ACCESS REPORT

DEVELOPMENT APPLICATION

77-79 BATHURST STREET & 86-94 CASTLEREAGH STREET LIVERPOOL

MIXED RETAIL / RESIDENTIAL DEVELOPMENT

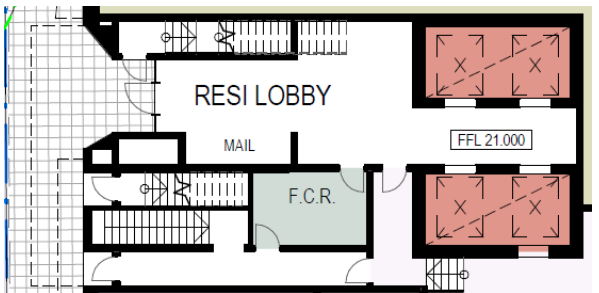
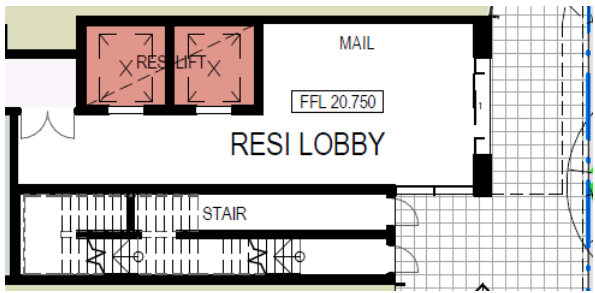
<ol style="list-style-type: none"> 1. The development occupies a site that has three street frontages with retail/commercial uses and two residential entrance lift lobbies that serve two towers to the east on Bathurst Street and to the west on Castlereagh Street. 2. The Memorial Avenue frontage shall incorporate a 10m X 45m outdoor plaza that adjoins a potential restaurant and a lift lobby to the basement level 1 retail parking. 3. The general topography of the site and adjacent public domain is very moderate with less than 1000mm height variation across the site which enables on-grade accessways from the public domain footpaths to all retail/commercial tenancies and common lobby entrances. 	<p>YES</p> <p>YES</p> <p>YES</p>
<ol style="list-style-type: none"> 4. Memorial Avenue – While the proposed FFL 21.000 floor level has a 330mm to 620mm height difference to the public domain footpath the 10m setback provides ample opportunity to incorporate 1:25 or less gradient accessways to the ground floor restaurant tenancy and carpark lift lobby to ensure level threshold entries in accordance with AS1428.1 to satisfy Parts D3.2 and D3.3 of the BCA. 5. The entry lobbies include swing doors with ample circulation spaces in accordance with AS1428.1 to satisfy Parts D3.2 and D3.3 of the BCA. 6. Where the outdoor plaza proposes a stairway then the first riser or ramp must be setback at least 900mm a future design stage to accommodate handrails and tactile indicators and stairway nosings in accordance with AS1428.1 and AS1428.4.1 to satisfy Parts D3.3 and D3.8 of the BCA. 	<p>YES</p> <p>YES</p> <p>YES at CC stage</p>

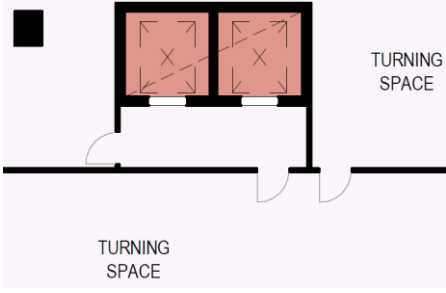
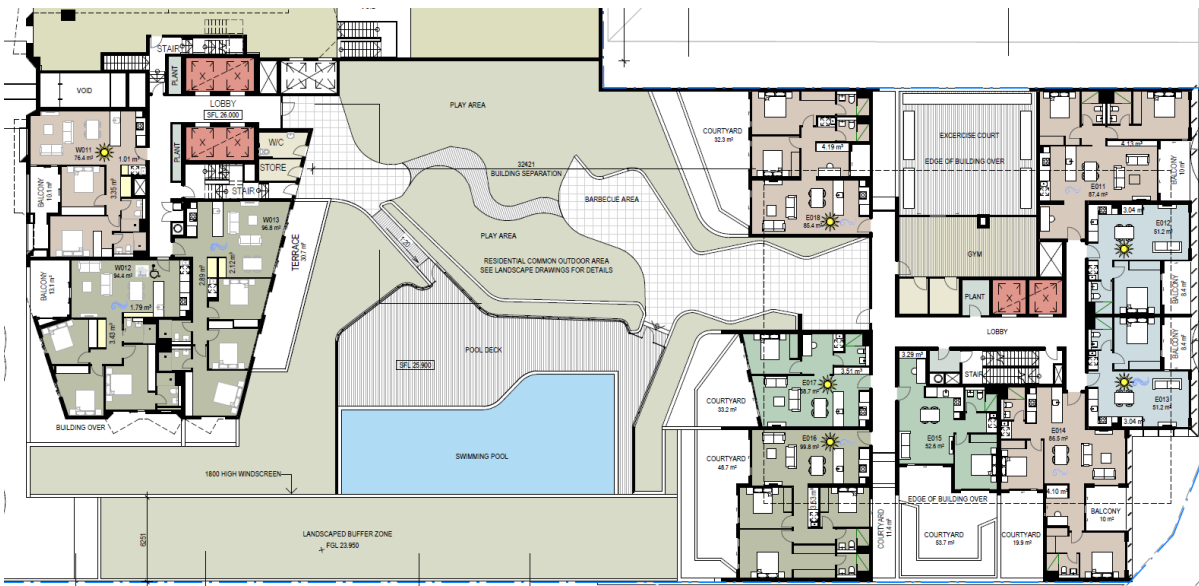
BCA / DDA Access Code Review	Complies
<p>7. Bathurst Street - The plans propose two retail tenancies and a residential lift lobby. The Retail 1 and lift lobby proposes FFL 20.670 which will enable a level doorway landing and level threshold from the public domain footpath @RL 20.600 to comply with ASI428.1 and satisfy Parts D3.2 and D3.3 of the BCA.</p> <p>8. The Retail 2 level of FFL 21.000 closely aligns with the public footpath and will achieve a level doorway landing and level threshold to enter the lobby to comply with ASI428.1 and satisfy Parts D3.2 and D3.3 of the BCA.</p> <p>9. The entry lobby and retail tenancies illustrate auto sliding doors to ensure appropriate access for people with disabilities.</p>	<p>YES</p> <p>YES</p> <p>YES</p>

10. Castlereagh Street – The plans propose a commercial tenancy and a residential lift lobby. The commercial tenancy and lift lobby levels of FFL 21.000 closely align with the public footpath and will achieve level doorway landings and level entry thresholds to comply with ASI428.1 and satisfy Parts D3.2 and D3.3 of the BCA.	YES

11. Details regarding door sizes, door hardware, level thresholds, doorway luminance contrast and accessible intercom controls shall be documented at the construction certificate stage in accordance with ASI428.1 to satisfy Parts D3.2 and D3.3 of the BCA.	YES at CC stage

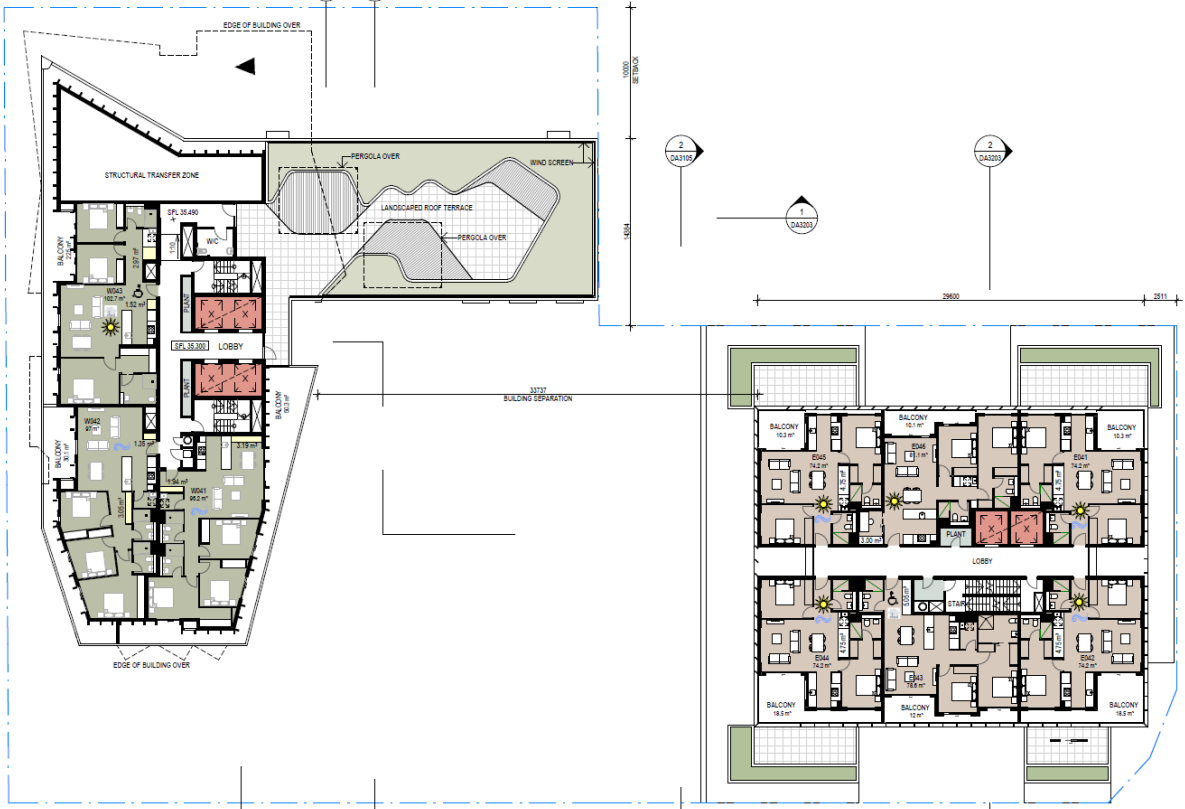
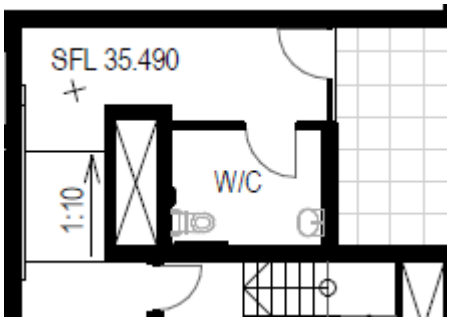
BCA / DDA Premises Standards Review	Complies
<p>12. Ground Floor Retail – The plan illustrates four (4) separate retail/commercial tenancies with open plan areas across a single floor level, which facilitates equitable access to all areas in accordance with ASI428.1 to satisfy Part D3.3 of the BCA and DDA Premises Standards.</p> <p>13. Restaurant – With respect to the restaurant the plans illustrate two lifts and stairway that facilitate equitable access between the ground and first floor levels to comply with Part D3.3 of the BCA and DDA Premises Standards.</p> <p>14. The rear access ramp and stair to the loading dock are deemed exempt from all accessibility requirements associated with ASI428 due to the nature of usage of the loading, which is consistent with the provisions of Part D3.3 of the BCA and DDA Premises Standards.</p>	<p>YES</p> <p>YES</p> <p>YES</p>

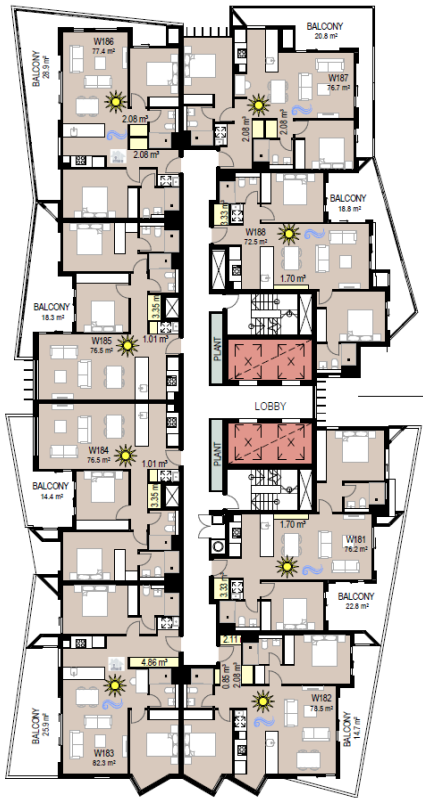
16. The development proposes 12 retail/commercial and a total of 27 visitor car spaces within the basement I carpark, which includes 4 accessible retail and 4 accessible visitor spaces easily complying with Table D3.5 of the BCA and DDA Premises Standards.	YES

17. The design of the Accessible Parking spaces providing 2400mm minimum width adjoining a 2400mm width shared area complies with AS2890.6 to satisfy Part D3.5 of the BCA and DDA Premises Standards.	YES

18. The accessible parking will be situated on generally level pavement no steeper than 1:40 to comply with AS2890.1 and direct access to the common retail lift.	YES

19. 2200mm minimum entry and driveway aisle heights and 2500mm height over the accessible spaces shall be confirmed at construction certificate stage in accordance with AS2890.6.	YES at CC stage

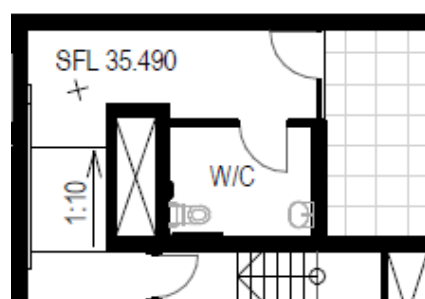
<p>Level 4 Outdoor Terrace –</p> <p>36. The western tower incorporates ramp access to a communal roof terrace area which includes a unisex accessible toilet in accordance with AS1428.1 to satisfy Part D3.3 of the BCA.</p>	 <p>YES</p>
<p>Levels 5 to 7 (8 to 17 similar)</p>	
<p>37. Eastern Tower - The 2000mm width lift landing and central corridor inherently facilitates Turning and Passing Areas in accordance with AS1428.1 to satisfy Part D3.3 of the BCA.</p>	<p>YES</p>
<p>38. Western Tower - The 2000mm width lift landing provides access to 1600mm minimum common corridors to the west, which enable to access to apartment entrance doorways, Passing Areas and facilitate 1540 X 2070mm Turning Areas at the end of the accessways in accordance with AS1428.1 to satisfy Part D3.3 of the BCA.</p>	<p>YES</p>

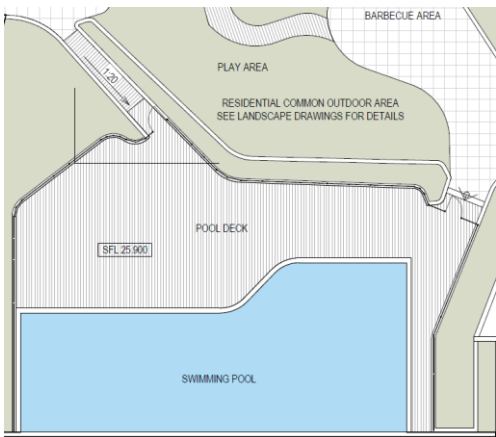
BCA / DCP Access Review		Complies
<p>48. Level 4 of the west tower provides a communal sanitary facility which provides 2100mm X 2800mm with a 1600mm minimum width corridor approach and 530mm minimum latchside clearance to the external doorway to comply with AS1428.1 and F2.4 of the BCA. Fittings and fixtures will be provided at construction documentation stage.</p>		YES
